ALERT SERVICE BULLETIN

NO. 206-09-124

MODEL AFFECTED: 206A/B

SUBJECT: HYDRAULIC SYSTEM OR CONTROL BOOST SWITCH – OFF CHECK, CHANGE OF.

Figure 1

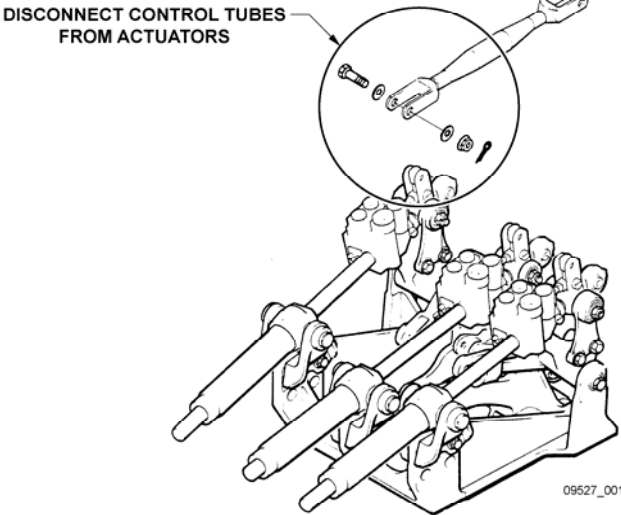
1. Ensure the electrical power and hydraulic systems are turned off.
2. Disconnect control tube from each hydraulic actuator. Protect control tubes from damage. Refer to Figure 1.
3. Using the temperature measuring device, ensure actuators are at minimum room temperature of 60°F (16°C).
4. Make sure friction is removed from both the cyclic and the collective flight controls.

Figure 2

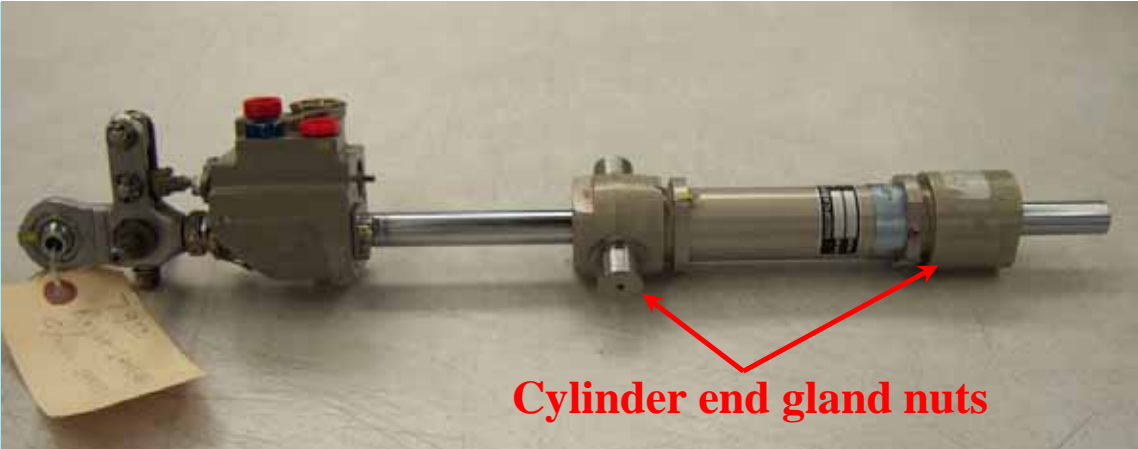
11. Using a heat gun, heat the boost actuator cylinder end gland nuts uniformly and all around the circumference to 160°F to 180°F (71.11 to 82.22°C). Repeat step 5 through 10 and record results in Table 1. (Refer to figure 2).
